# Safety Evaluation Report

Related to the License Renewal of the  
Point Beach Nuclear Plant Units 1 and 2

Docket Nos. 50-266 and 50-301

U.S. Nuclear Regulatory Commission

**Table 4.5-1 Unit 2 Hoop Tendons, Projected Pre-stressing Force Trend**

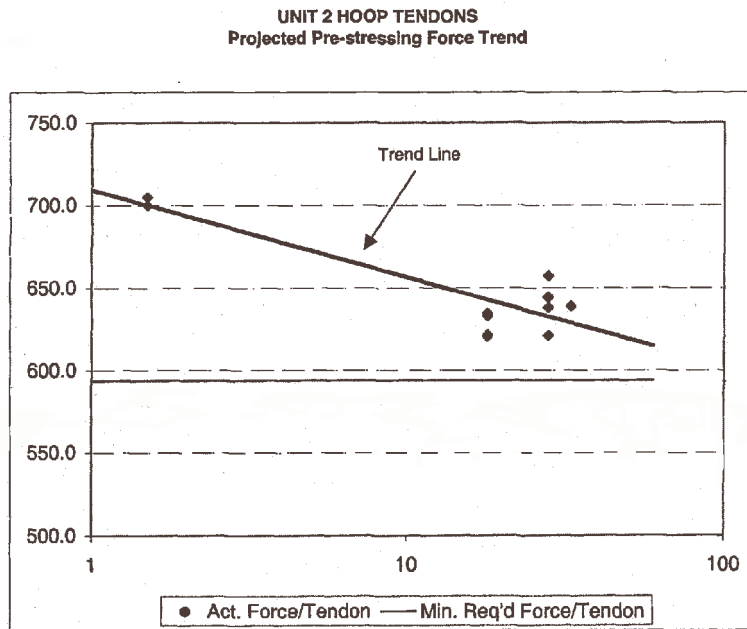
In response to RAI 4.5-1 (2) and (3), the applicant provided the prestressing force plots with the trend lines of the projected prestressing forces for each group of tendons out to 60 years. The initial plots attached to LRA Section 4.5 were based on the lift-off testing of common tendons. The approach was not acceptable, as it was based on measurements of one tendon in a group. The staff recommended the applicant to develop the trend lines from all measured lift-off data, using a linear regression analysis. The applicant developed the trend lines using linear regression analysis and utilizing all measured lift-off force data. In a draft response, the applicant noted that this trend line information was based on draft calculations, and that it intended to resubmit the information, if the final approved calculation revealed a different conclusion.

During a meeting on February 15, 2005, the staff indicated and the applicant agreed, that this response required further clarification. In its response, a clarification letter dated March 15, 2005, the applicant provided the corrected final plots showing the trend lines and the actual measured prestressing forces. Graphic table 4.5-1, shows a plot for Unit 2 hoop tendon reproduced for illustration purposes.

The staff found the process used in arriving at the tend lines to be in conformance with the provisions of NUREG-1800 Section 4.5.3.1.2, and therefore, it is acceptable. The staff recognizes that the slopes of the trend lines could change as a result of the prestressing tendon measurements taken during future inspections. However, the applicant will evaluate the results pursuant to IWL-3221.1(c), and take corrective actions as stipulated in the LRA. The staff's concerns described in RAI 4.5-1 are resolved.
